Model: Iris/Lilac/Cattleya Platen Cover		Date: 24-Oct-01	No.: RA749001
Subject: Platen Cover Hinge		Prepared by: M. Tsuyuki	
From: Technical Services Dept., GTS Division			
Classification:	<input type="checkbox"/> Troubleshooting	<input type="checkbox"/> Part information	<input checked="" type="checkbox"/> Action required
	<input type="checkbox"/> Mechanical	<input type="checkbox"/> Electrical	<input type="checkbox"/> Service manual revision
	<input type="checkbox"/> Paper path	<input type="checkbox"/> Transmit/receive	<input type="checkbox"/> Retrofit information
	<input type="checkbox"/> Other ()

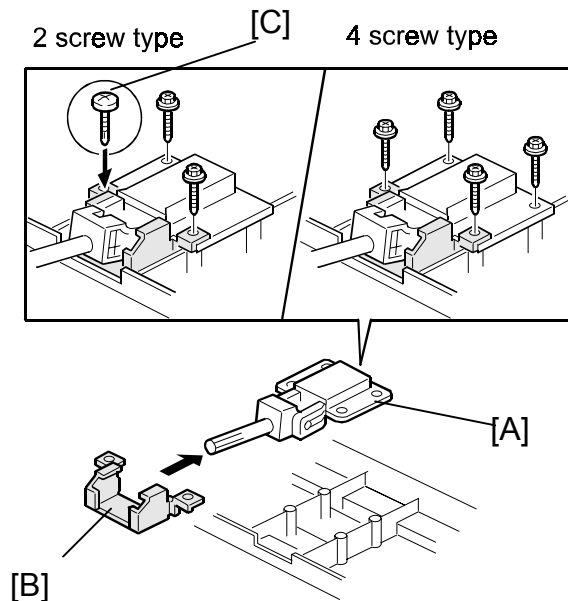
When the platen cover is opened and/or closed, the hinge of the cover breaks and a hinge fragment may hit the user's face.

Install the cover for the platen cover hinge as shown at the next service visit (P/N A7499451).

1. Remove the platen cover hinge [A].
2. Attach the cover [B] to the platen cover hinge as shown.
3. Re-install the hinge with the cover.

If the platen cover hinge has two screw holes, use the self-tapping screw [C] packed together with the cover.

The cover has been added to the hinge and the hinge has been further strengthened from August 2001 production.
